Manufacturing Notice

Name:	Final Finish on Vertical Mount Ashtray Receptacle
-------	---

Name:	Final Finish on Vertical Mount Ashtray Case & Bezel
-------	---

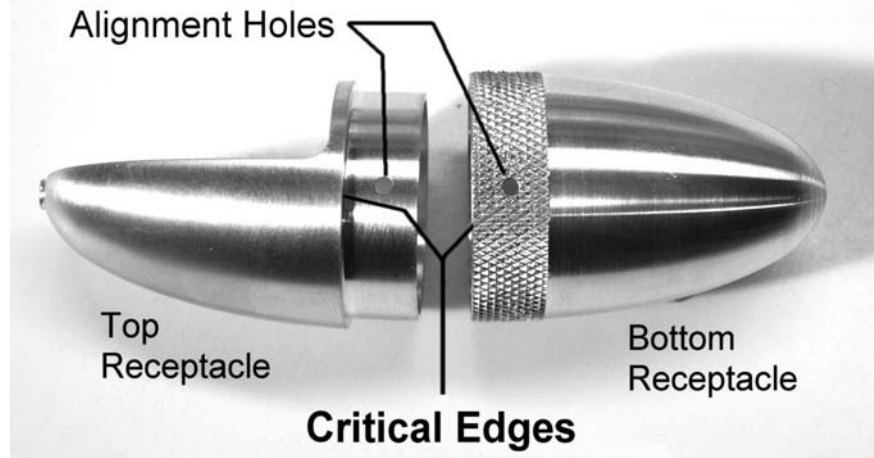
Final finish build-up on critical edges must be minimized to allow Receptacles to fit together so holes are aligned.

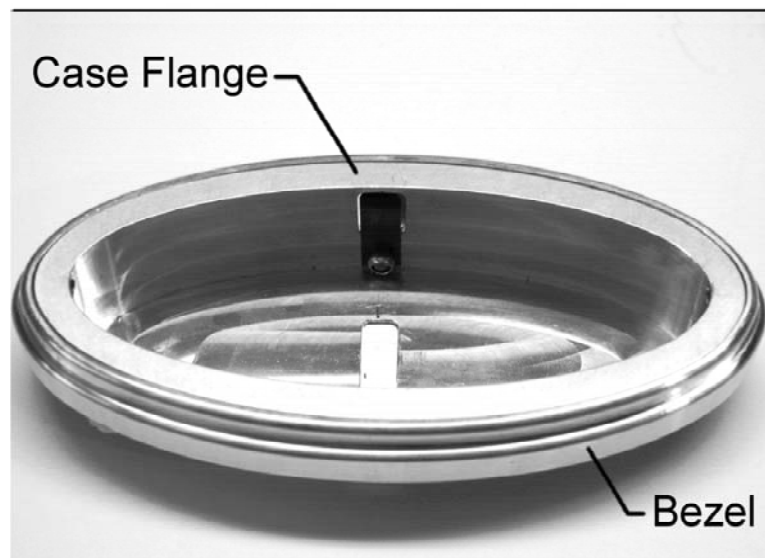
Bezel must fit flush down inside the recess on the Case Flange.

Maximum final finish thickness on the edge of the Bezel or on the inside of the recessed area of the Case Flange to be no greater than 0.005". Remove any localized buildup or pooling of final finish on edges or in corners.
